## **ADDENDUM #2**

### **PROJECT: Firebaugh Center Surveillance Cameras**

Camera RFQ Plans – Addendum 2.pdf

TECHNOLOGY LEVEL 1  
 OVERALL REFLECTED  
 CEILING PLAN

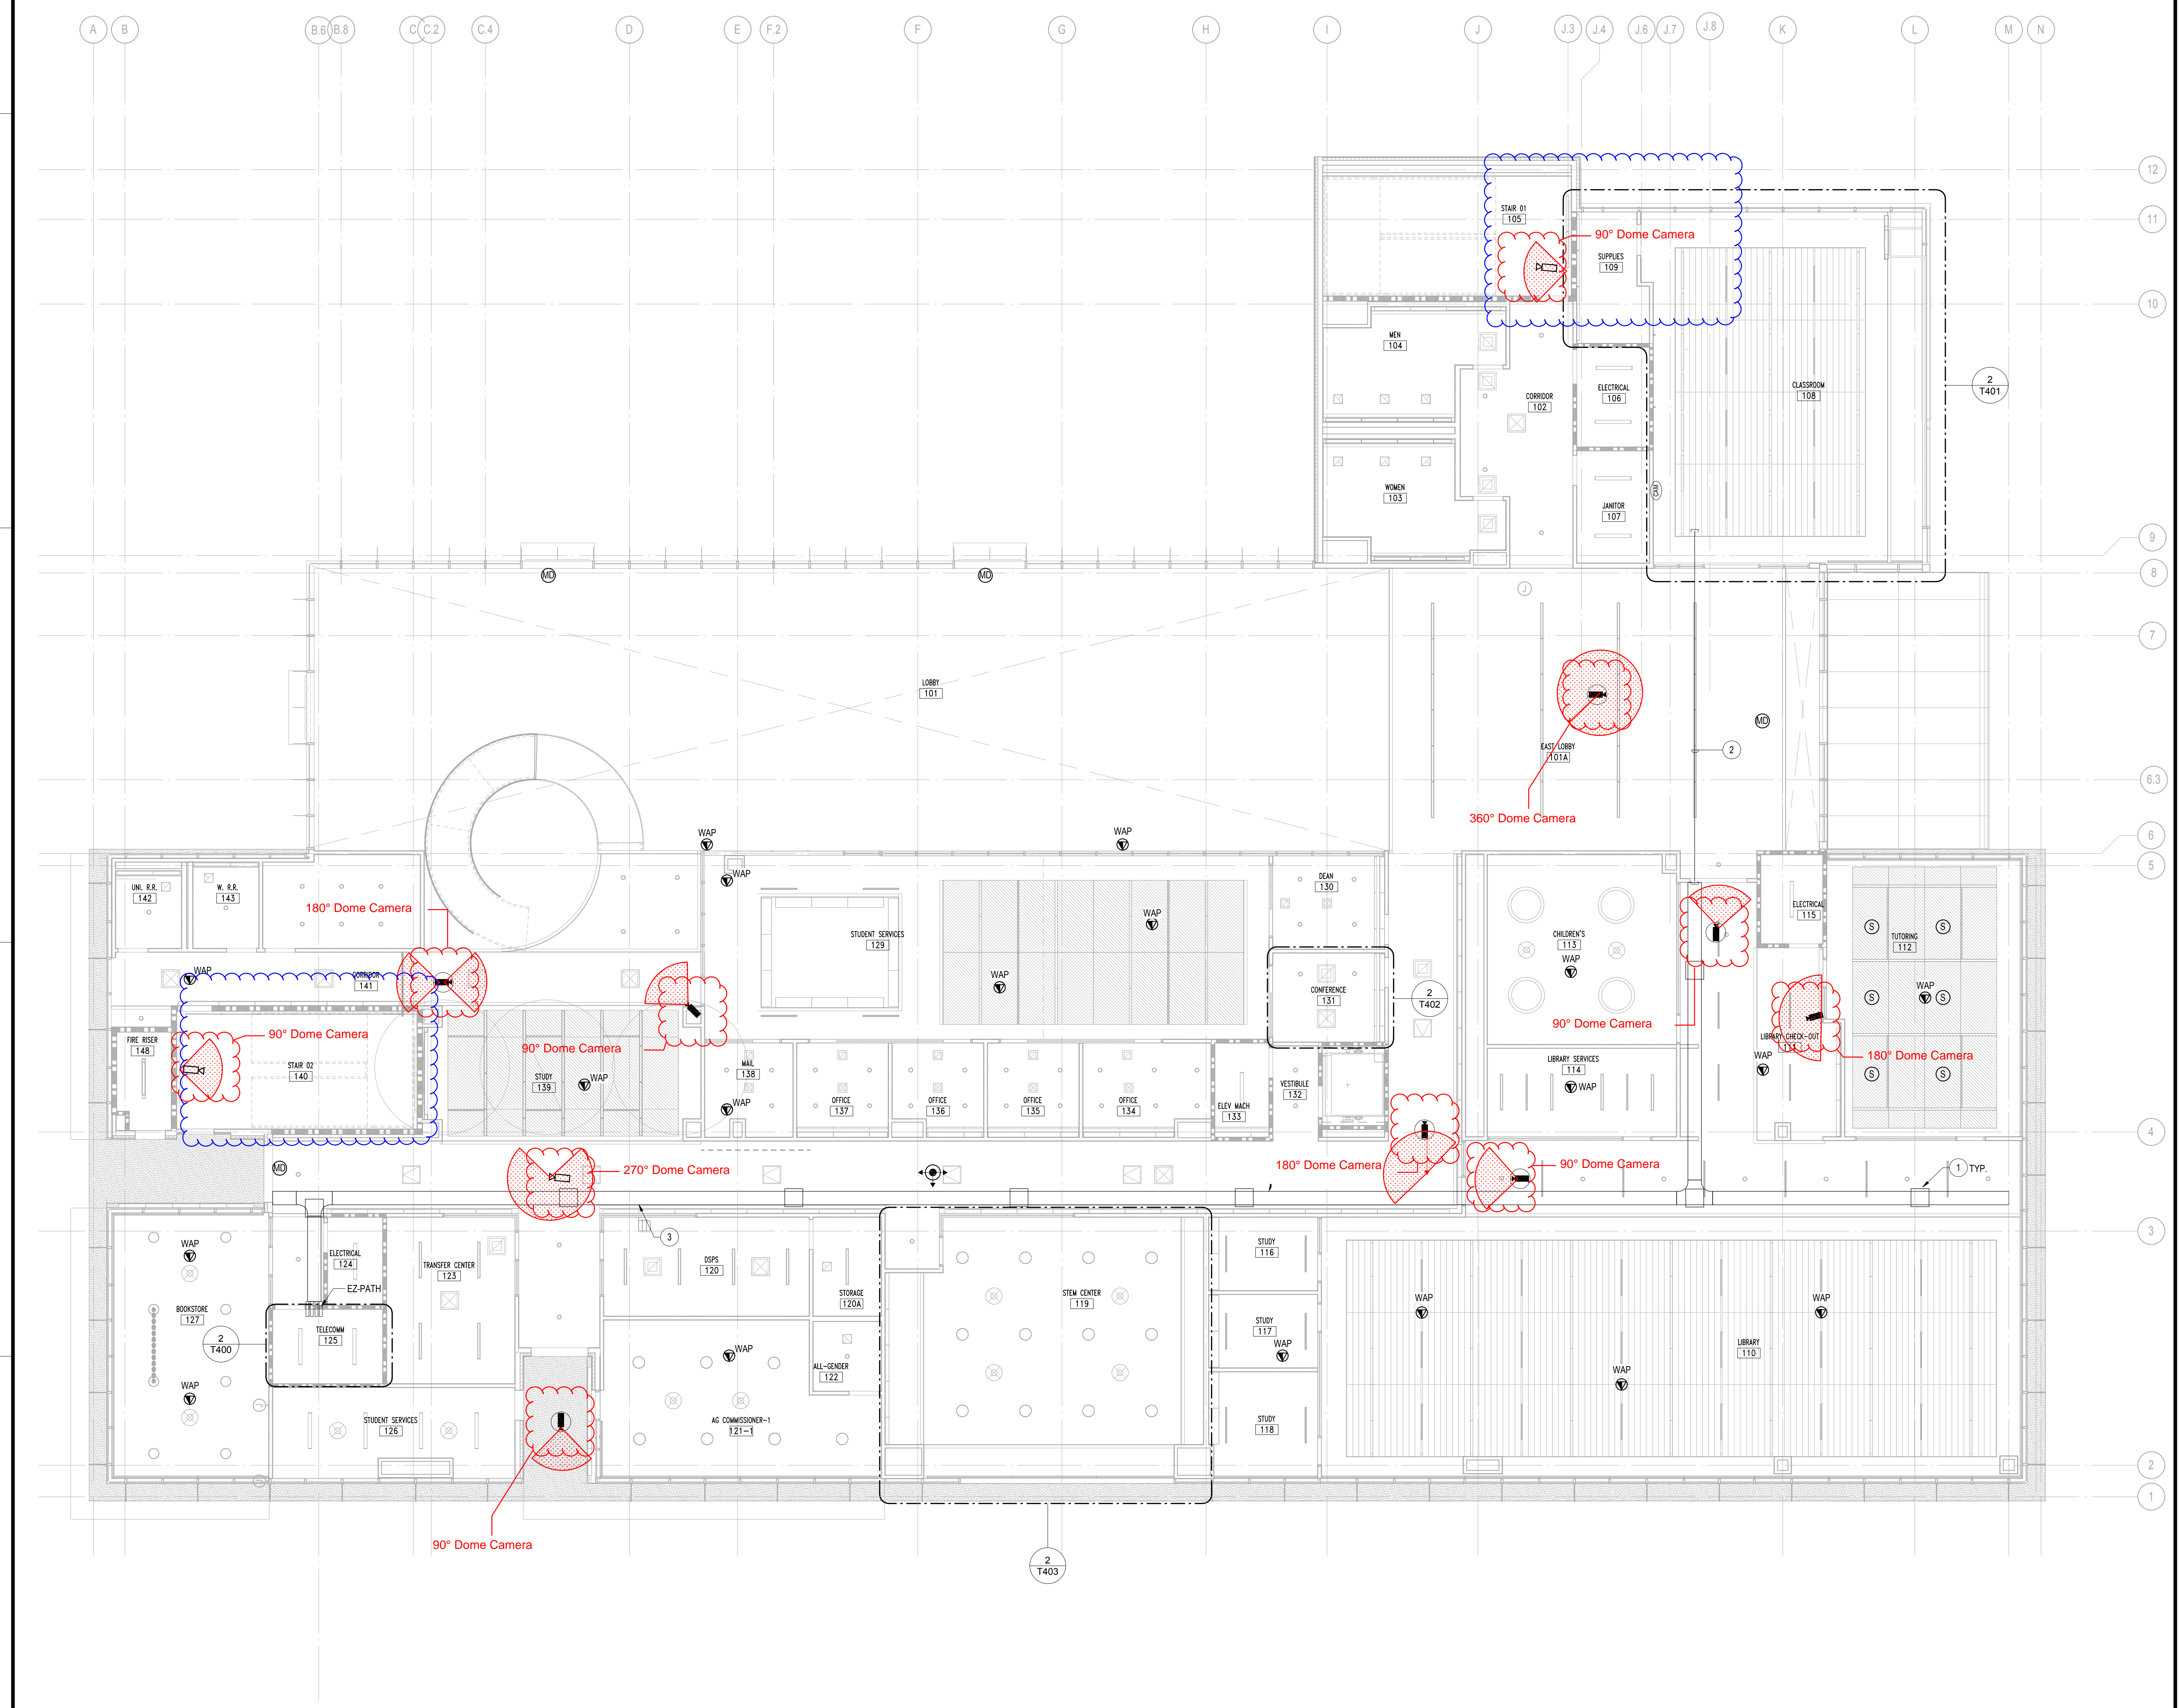
- The 180-degree dome camera in the SE corner adjacent to vestibule 132 in the first-floor hallway will need to be mounted approximately 4ft away from the network jack location to obtain the indicated view. This cabling extension will need to be pulled above the ceiling in the crawl space (not surface-mounted).

- Hallway camera facing Telecom 223 was mis-labeled as 180 degree camera and was corrected to 90 degree labeling.
- Stair 232 – 180 degree camera changed to 2x 90 degree cameras.
  - One located on the west wall of Stair 232 on the second floor.
  - The second located in stair 140 east wall on the first floor.
  - This adds an additional network drop.
